Product Change Notification / MFOL-05LHKQ810

CCB 5253 Initial Notice: Qualification of MTAI as an additional final test site for MIC5219-5.0YMT-TR and MIC5219YMT-TR catalog part numbers available in 6L UDFN (2x2x0.6mm) package.

Description of Change:Qualification of MTAI as an additional final test site for MIC5219-5.0YMT-TR and MIC5219YMT-TR catalog part numbers available in 6L UDFN (2x2x0.6mm) package.

Pre and Post Change Summary – Pin 1 Orientation

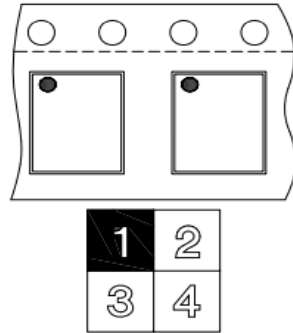
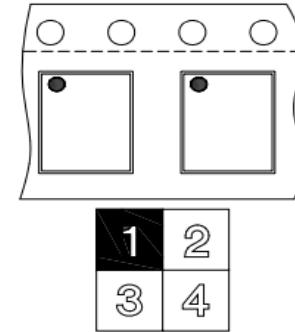
Quadrant 1

Quadrant 1

Pre and Post Change Summary - Carrier Tape

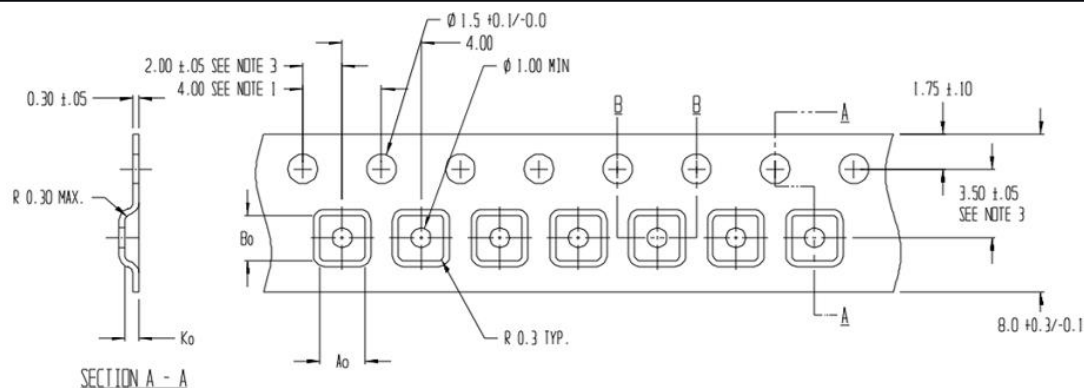
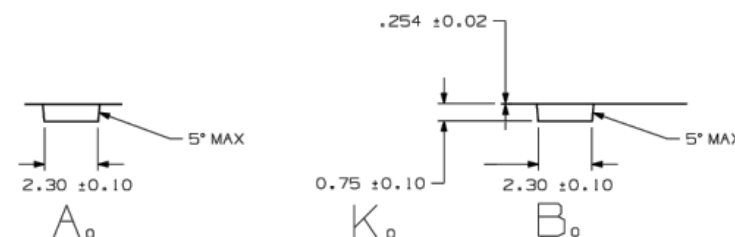
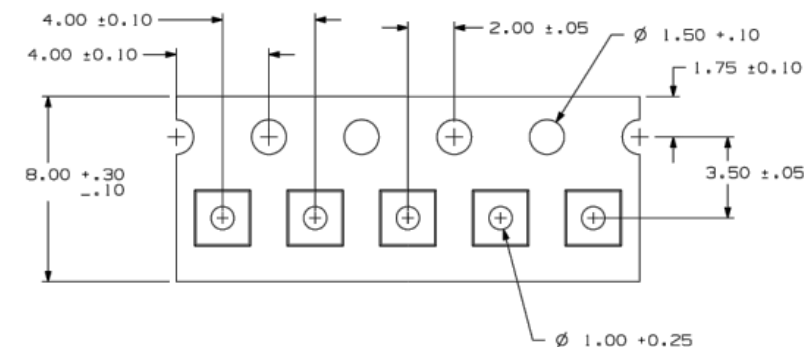
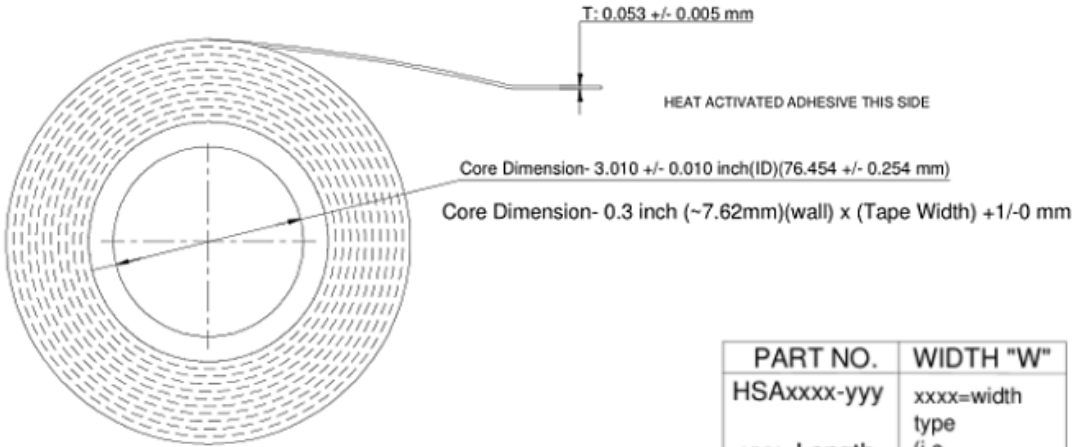
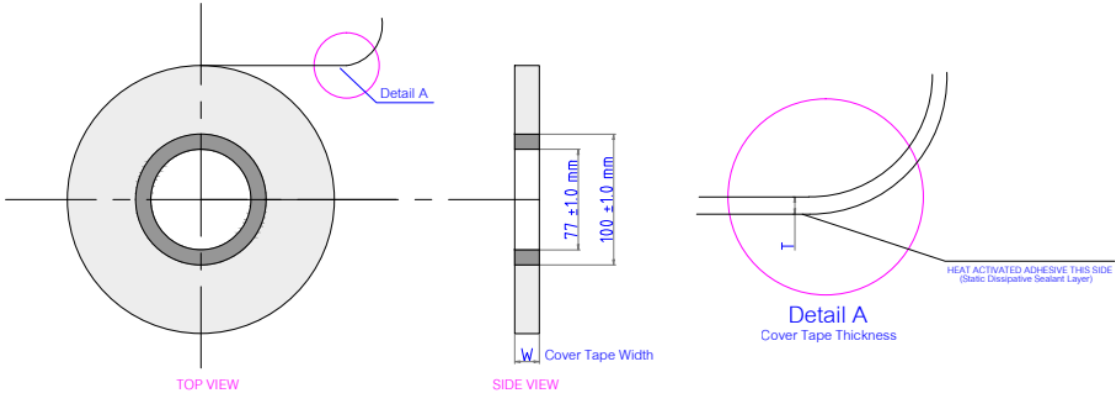
Plant	W (mm.) ± 0.3 or Specific	P (mm.) ± 0.1 or Specific	A ₀ ± 0.1 or Specific	B ₀ ± 0.1 or Specific	K ₀ ± 0.1 or Specific
UNIC	8.00+03/-0.1	4.00mm	2.30mm	2.30mm	0.70mm
MTAI	8.00+0.3/-0.1	4.00mm	2.30mm	2.30mm	0.75mm

Pre and Post Change Summary - Plastic Reel

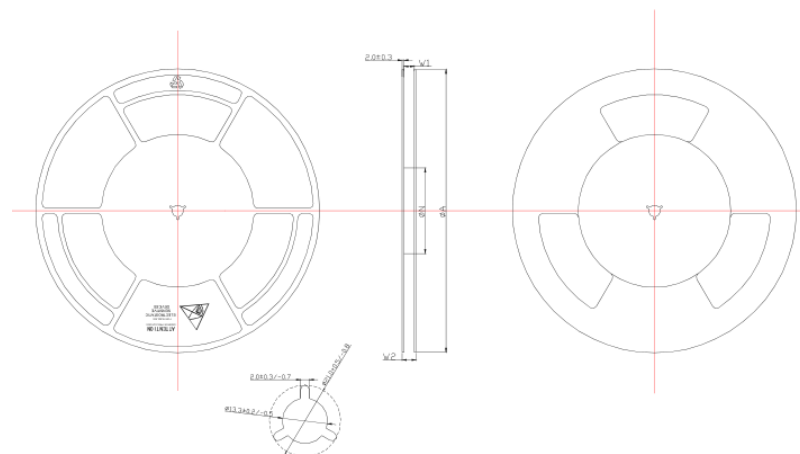
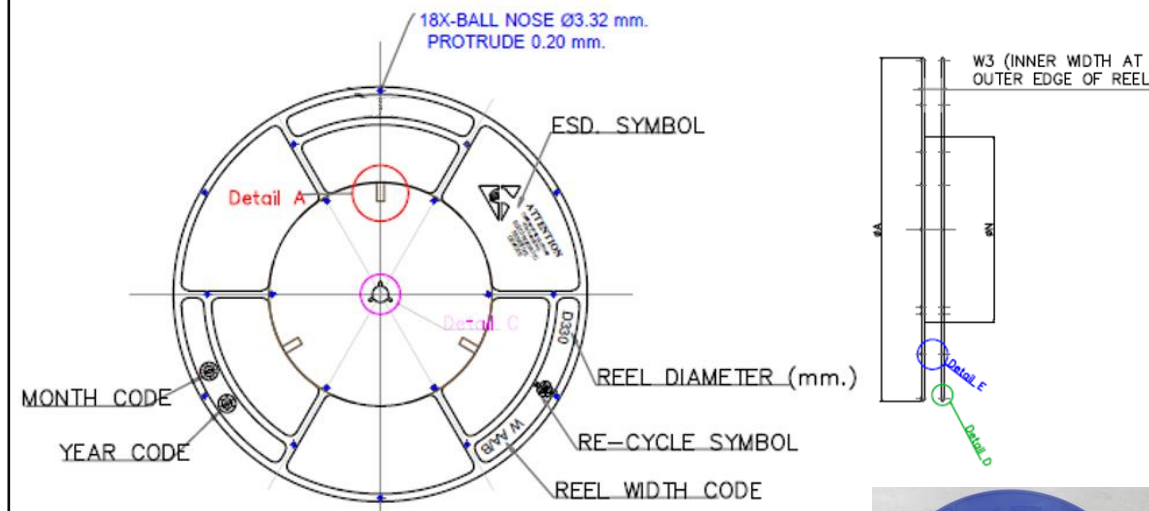
Plant	Reel diameter	Reel Hub Size (mm)	Reel Width Max (mm)	Reel Color
UNIC	330 +/- 2.0	178 +/- 1.0	15.4	White
MTAI	330 +/- 2.0	178 +0/- 2.0	14.40	Dark Blue

Pre and Post Change Summary – Static Shielding Bag

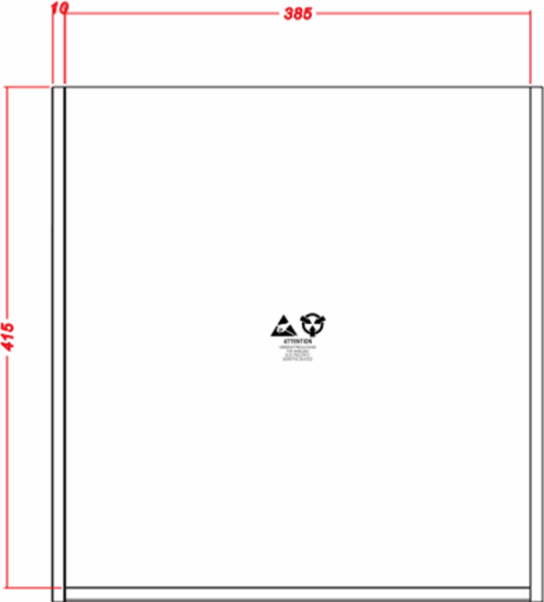
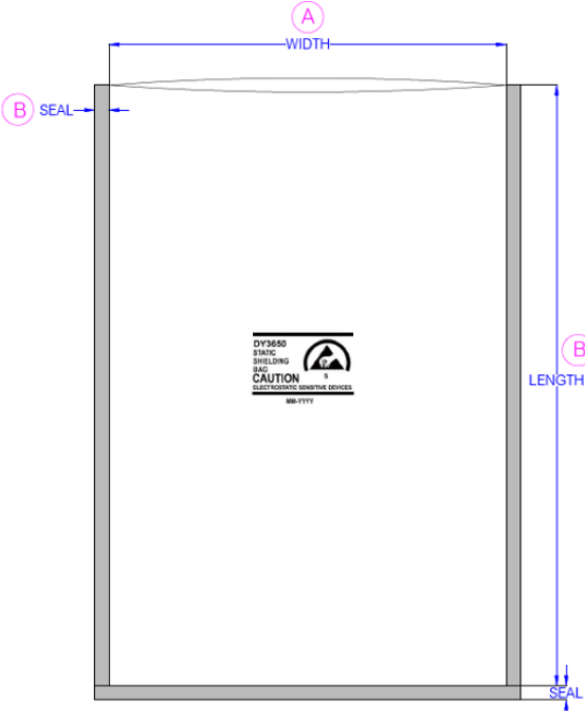
Plant	Length (mm)	Width (mm)	Thickness (mm)
UNIC	415	385	0.08
MTAI	420	370	0.076
